Meghan Pump Station (RFCSP)
Solicitation Number: CO-00645
Job No.: 19-1006

ADDENDUM 4
October 20, 2023

SHEET NO.
E3
37 OF 67

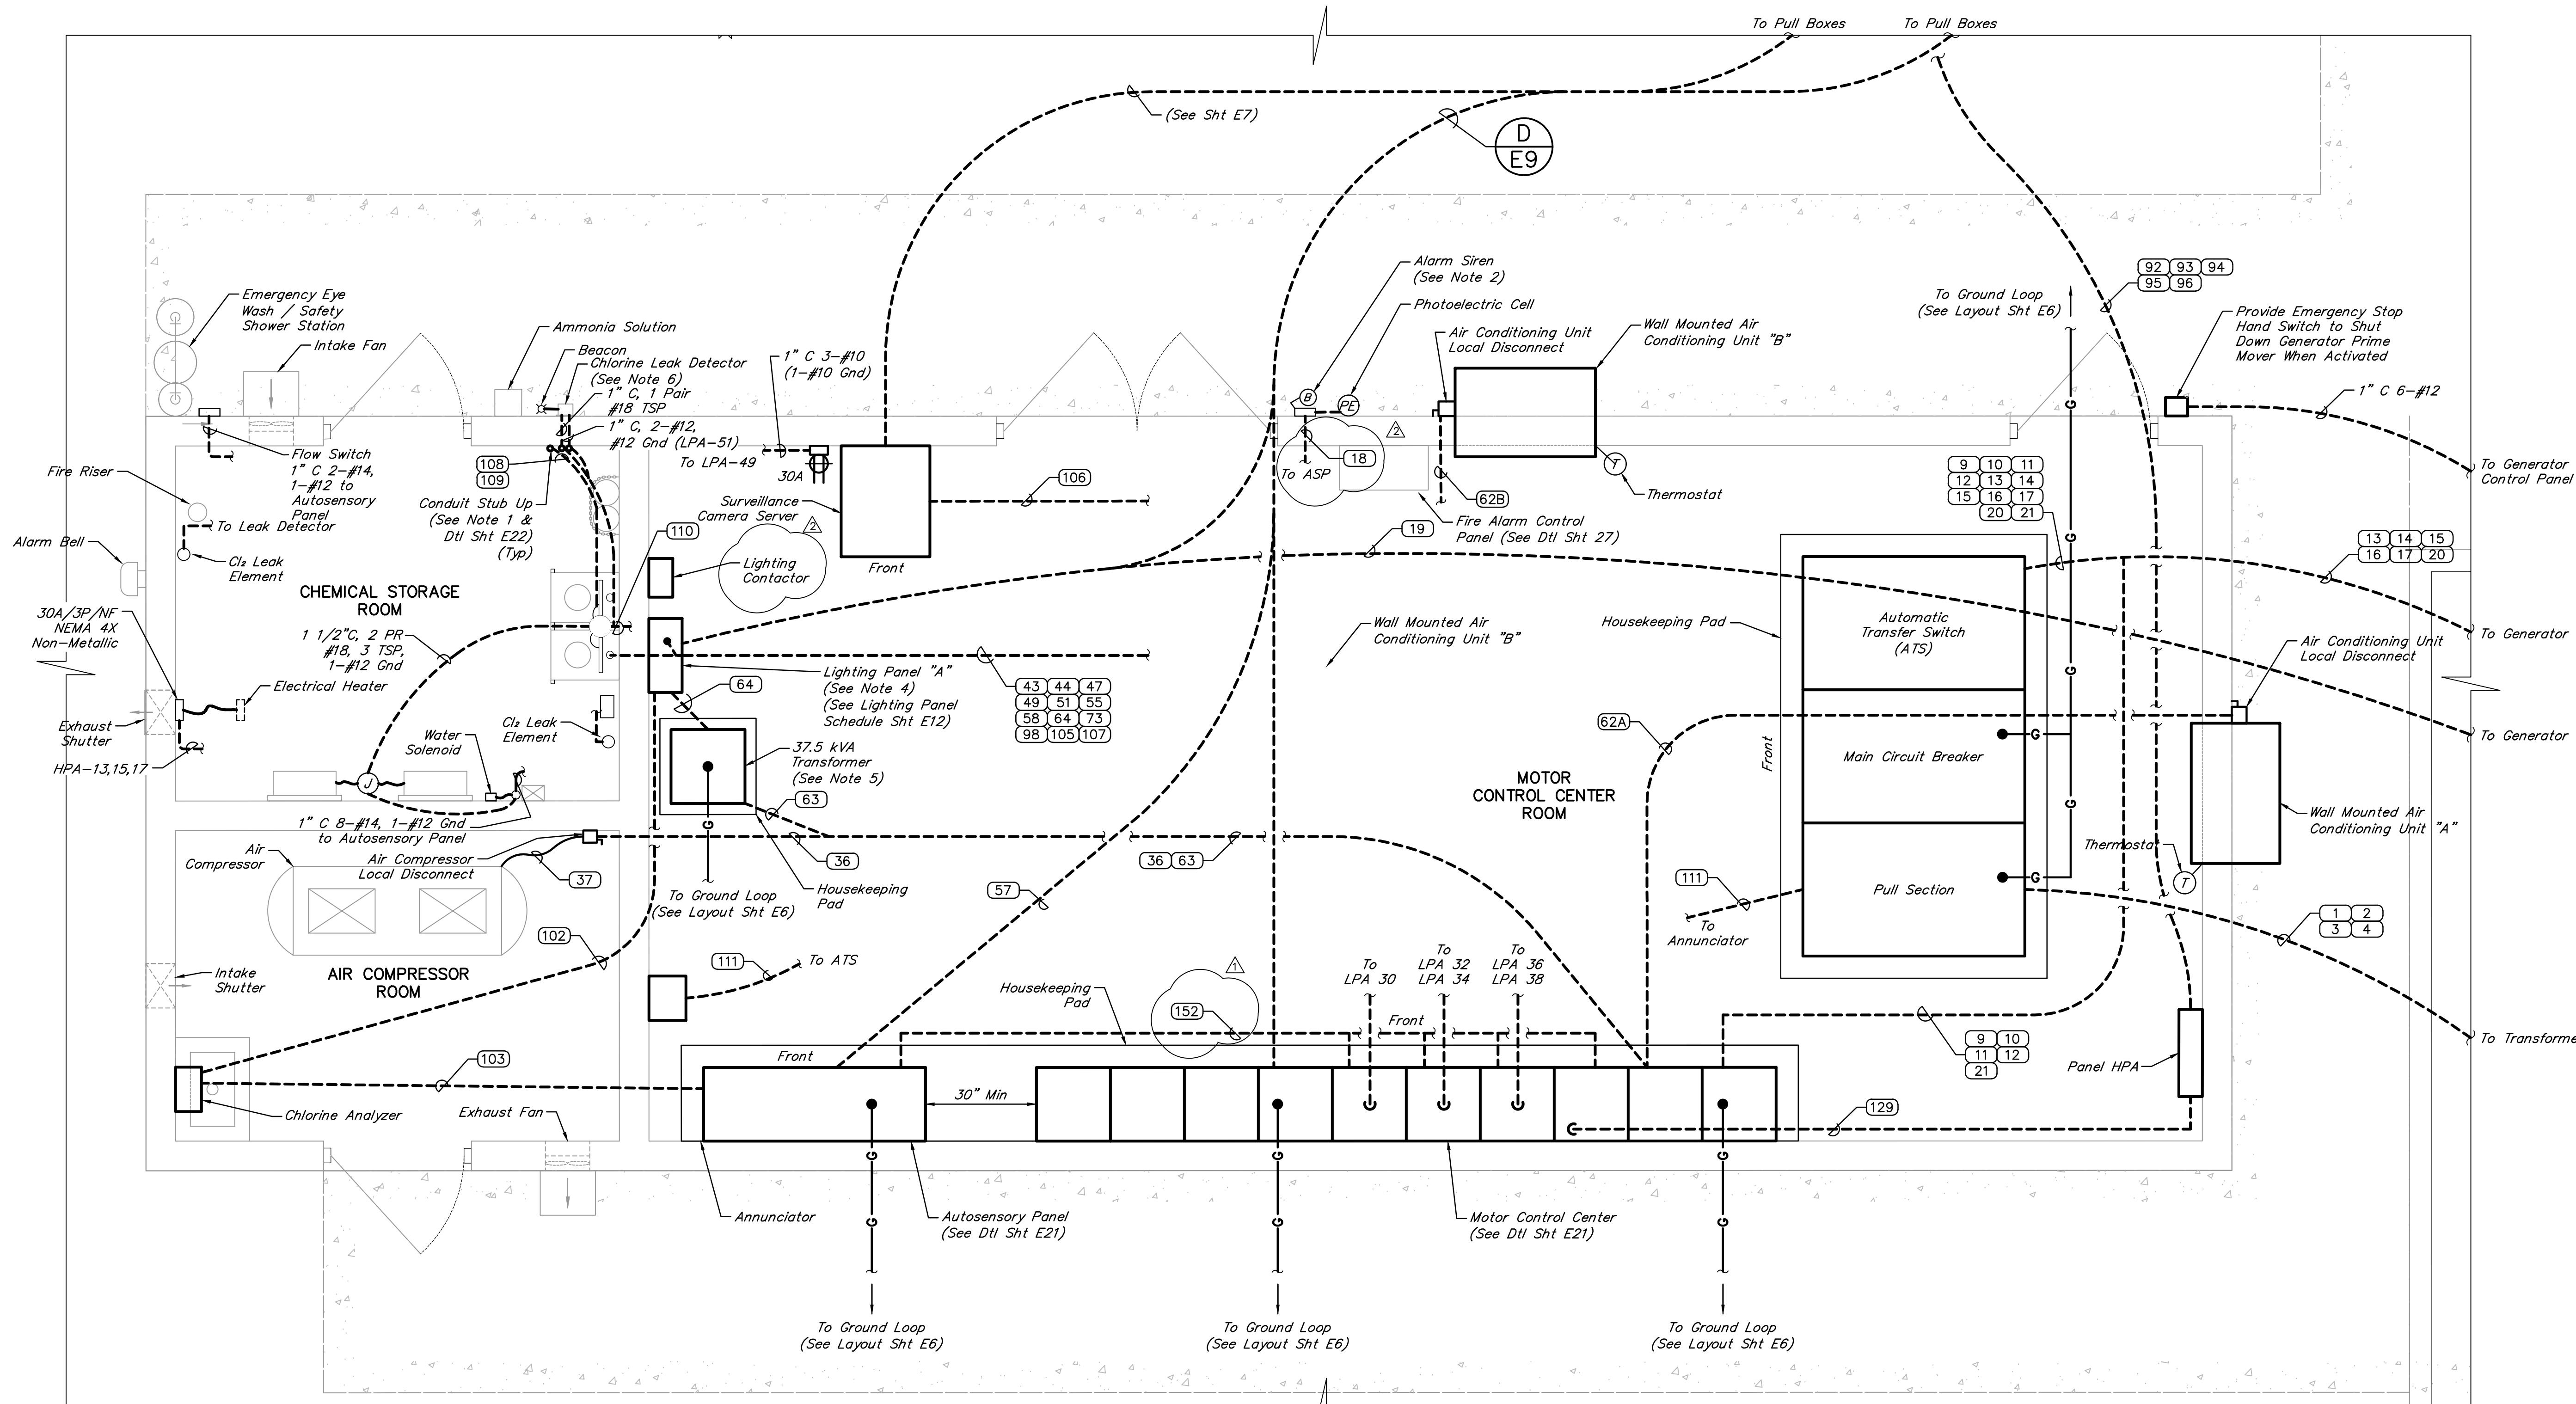
3. Electrical Building drawings does not show the location of Lighting Contactor Panel and photo cell circuit #18 on conduit schedule sheet E9 is routed to the Autosensory panel. Is it the intention for the Autosensory panel to include Lighting Contactor & Time Clock shown on E12 and E11 item #6 & item #19?

4. Related to the above, shouldn't all exterior lighting circuits be routed to Lighting Contactor panel? Wherever it may be, current conduit schedules shows routed directly to LPA. Also the LPA circuits #3, #7, #9 to be routed to the lighting contactor is not showing on any plans?

Response: See #1, Changes to Plans, in this addendum. The Lighting Contactor shall be installed adjacent to LPA inside of the Control Building. Photocell and photocell circuit (#18) is located on the East side of building routed to Autosensory Panel as shown on E3 & E20. Modifications to include location of Lighting Contactor on E3 have been made.

Response: All exterior lighting circuits shall be routed through the Lighting Contactor but powered through their respective LPA circuits as shown on E11 and E20.

1. Remove Sheet 37 (E3) in its entirety and replace it with the version attached to this addendum.
2. Remove Sheet 35 (E1) in its entirety and replace it with the version attached to this addendum.
3. The correct solicitation number for this project is CO-00645. The cover sheet of the plans erroneously lists CO-00388. That number can be disregarded.
